To: Joe Turner, Hearings Examiner
 From: Sarah Fox, Senior Planner
 Date: December 27, 2017
 RE: Open record for Dawson Ridge Subdivision (File #SUB17-02)

City's Response to Exhibit 73

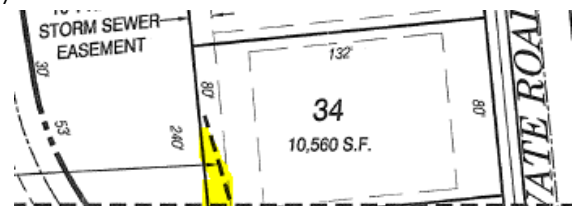
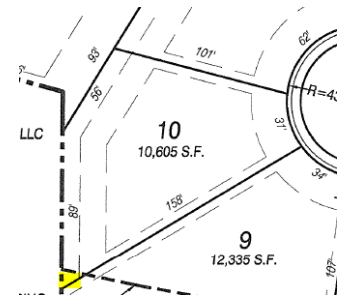
The applicant submitted an appeal to the SEPA MDNS (File #SEPA17-16), which included the conditions concerning geotechnical setbacks at seven (7) lots. The applicant reiterated their objections to those conditions within Exhibits 70 and 73.

As discussed in the Staff Report, the city must ensure the long term safety of areas that are identified as hazardous. The provision from city code as cited by the applicant for allowing structures such as fences and patios within the hazard area, is not an exhaustive list. As noted by city, there are provisions within Chapter 18.17 Supplemental Development Standards, which allow for more than fences and patios without a building or other development permit. If under a certain size, pools, hot tubs, sheds, gazebos, retaining walls, etc., can be built throughout the city within a private residential lot. Both the city's consultant and the applicant's geotechnical engineers agreed that that fences and patios were safe, however they both stated that fill should not be placed within these areas without additional geotechnical review. Given that the city must ensure that safety is maintained over the long term, the proposed conditions within SEPA are intended to meet that duty. Short term measures, such as signage in a backyard may serve their function until they are removed by accident or intentionally by the property owner.

Staff notes that the condition to place the setback area into a tract is inconsequential to five (5) of the seven lots. For example, **Lots 10, 31, 32, 33 and 34** could be adjusted to remove the setback area from the back of the lot and still meet the minimum depth of 100 feet.

The remaining two lots, Lots 8 and 9, are proposed to be pie-shaped at the end of a cul-de-sac. It would appear that the lots would meet the lot depth minimum, however there would be a challenge meeting the lot width minimum of 80-feet.

At the public hearing, the applicant requested additional flexibility in lot sizes for those lots that are affected by the set aside tract, *if the SEPA conditions are retained*. Staff could support a condition that is specific to **Lots 7 and 8**, which would allow them to utilize dimensional standards of R-12 zoning (minimum width of 70 feet and depth of 90 feet). The city would also support a condition to allow all seven lots to utilize the lot size range of the R-12 zone of 8,400 to 18,000 square feet (both R-12 and R-15 zones).

Figure 1 Potential views of the Columbia River

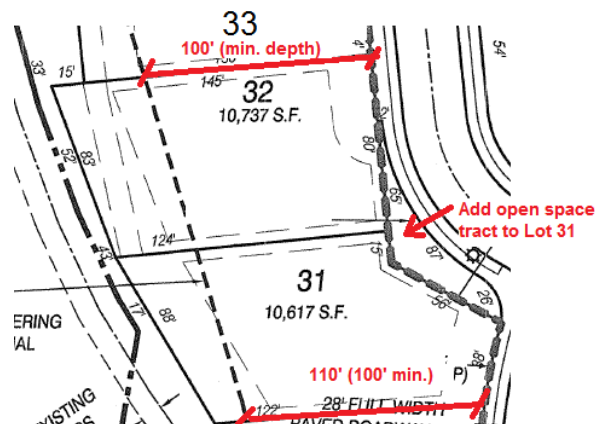
On December 18th, Pete Capell, City Administrator, and Robert Maul, Planning Manager ("the city"), met at the site with the property owner, David Lugliani, to discuss potential viewpoint locations. The city's photos that were submitted with the presentation materials were taken from the area of Tract B. They angled in the southerly direction from the tract. As clarified by the applicant at the hearing, that direction will someday be blocked by a home on the currently vacant adjacent lot. For these reasons, the open space Tract B would not be suitable for the viewpoint.

During their site meeting, the city and Mr. Lugliani discussed an alternate location, north of Tract B and west of the equestrian stables (See Figure 1). There is a potential view of the Columbia River to the west, although it is not entirely unobstructed with a few mature trees in the foreground. Mr. Maul noted that Mr. Lugliani was amenable to continuing to discuss this alternative location, as stipulated by Condition #13.

Given the confusion between the applicant and staff (and possibly, the public) in regard to the exact location of the views to the Columbia River, the city requests that an additional condition be included, consistent with CMC§ 16.33.010(C) Visual Analysis Required.

The applicant shall provide a public viewpoint of the Columbia River, and note the location on the plat map. The applicant shall provide a visual analysis consistent with the requirements of CMC§ 16.33.010(C), and must submit it prior to engineering plan approval. Limited pruning of trees within the view corridor will be allowed as performed by an arborist. "Limited" pruning means less than 20% of the limbs of a single tree can be removed within a five year period.
